MASON, ROBBINS, BROWNING & GODWIN

RE: Comment Letter—MID Draft Order
4/19/2011 BOARD MEETING—Consideration of a proposed draft Order regarding
Merced Irrigation District's request to stay Investigation Order WR 2011-0003-EXEC

RE: Revisions to study plan

Figure 1. Modeled water temperatures under the current operation scenario. Percent exceedance by month (January 1, 1980 -- September 30, 2006).

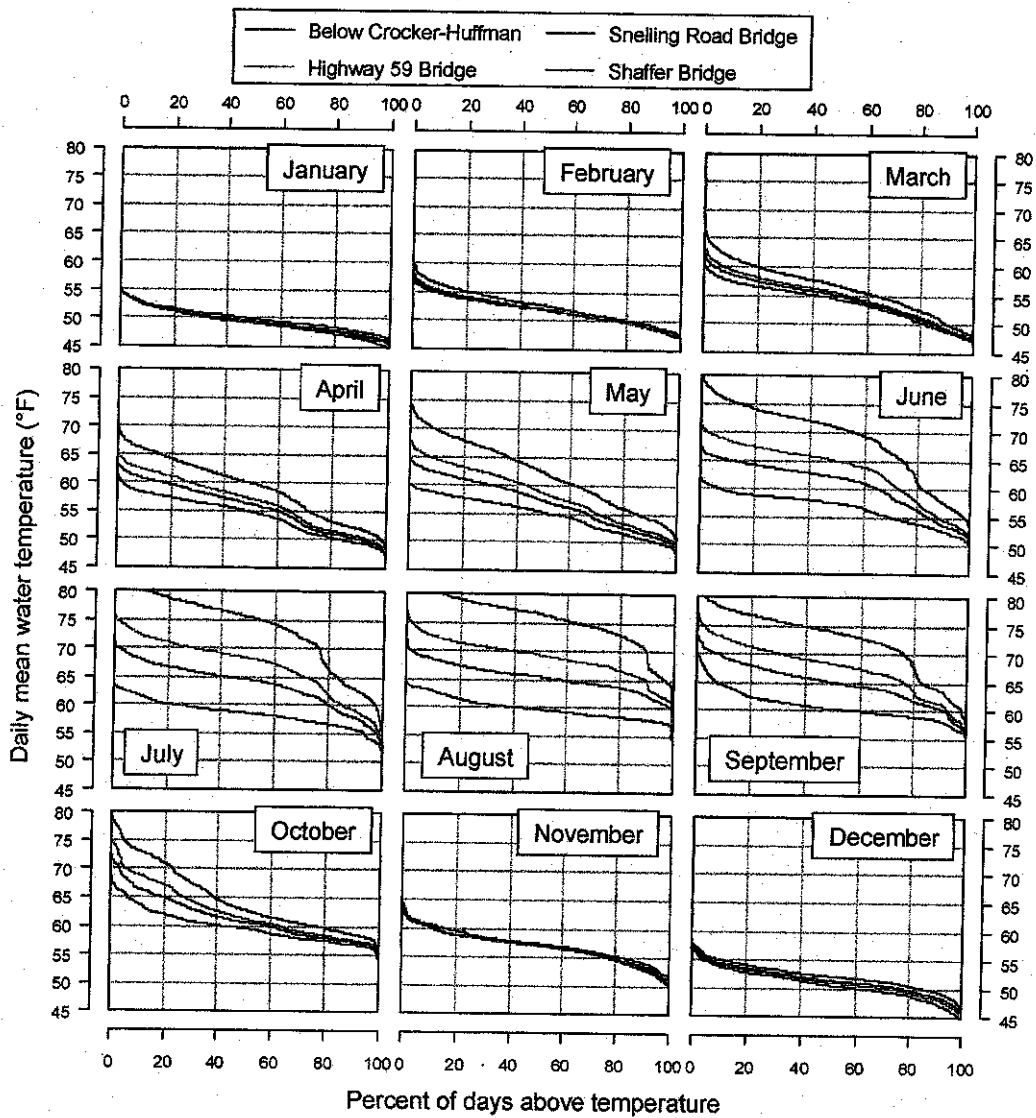
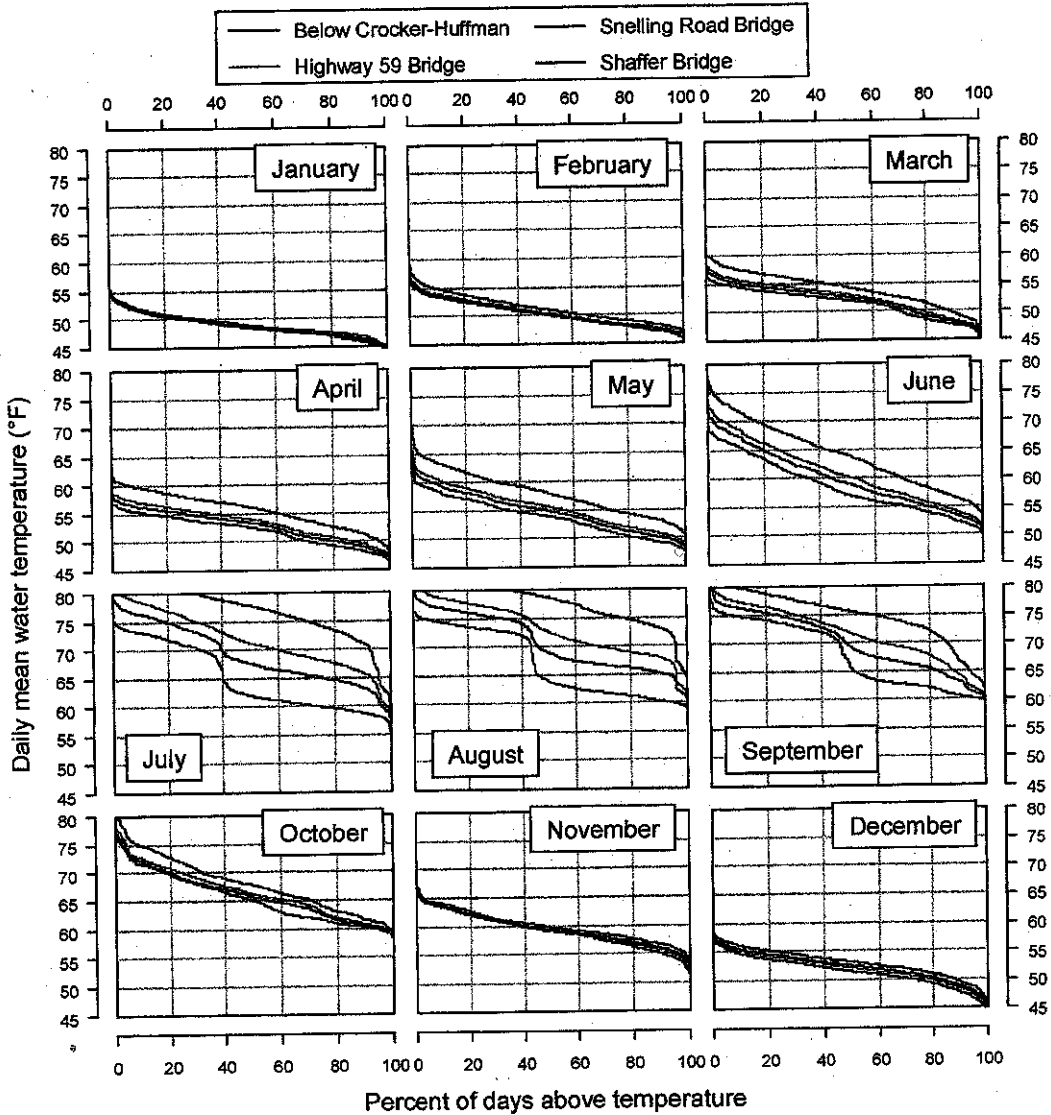
In our evaluation of the Water Temperature Model, we found that the model documentation is well organized and clearly written. We evaluated and confirmed that the model was performing as described. The model is well constructed, with an adequate set of input data and credible calibration. We found that there is a seasonal component to the prediction errors, in that the model tends to under-predict water temperatures in the summer and over-predict water temperatures in the winter. Nevertheless, the model provides reasonable results for the purpose of analyzing various flow scenarios.

Regarding potential project effects upon downstream water temperature, we suggest that early season project releases from New Exchequer dam have a direct impact on water temperatures in lower Merced River. The model shows that the downstream of the extent of the project impacts upon water temperatures are highly dependent upon operational scenarios, but typically extend several miles downstream of Crocker-Huffman from late spring through early fall, beyond which the influence of ambient meteorology would require large volumes of release water as a means to control water temperatures. Figure 1 illustrates the increasing effect of ambient meteorology, and decreasing correlation of project effects with increasing distance downstream of Crocker-Huffman. We note the increasing spread of, and dissimilarities of shape, of the temperature exceedance lines between March and October, where each line represents percent temperature exceedance at a different point downstream of Crocker-Huffman, indicates this decreasing correlation with project effects with increasing distance downstream. Furthermore, our evaluation of the Water Temperature model indicates that the relative magnitude of inflows and outflows can greatly influence water temperatures within Lake McClure and McSwain reservoir, thereby affecting water temperatures downstream of Crocker-Huffman. Larger early-season release of water reduces the available cold water pool within Lake McClure, which directly impacts the availability of cold water later in the season. This point is illustrated by figure 2, which represents percent exceedance by month for modeled water temperatures downstream of Crocker-Huffman under a hypothetical operating scenario which provides for a high magnitude pulse flow during late spring months (where flow at Shaffer Bridge is proportional to 60% of inflow to Lake McClure during the months of February and June). Under this scenario, downstream water temperatures demonstrate a better correlation to the release from Lake McClure from March through June (lines demonstrate less spread). However, from July through October, downstream water temperatures are more likely to exceed temperatures which are suitable for cold-water species, suggesting that an early-season pulse flow effectively exhausts the cold water supply from Lake McClure.
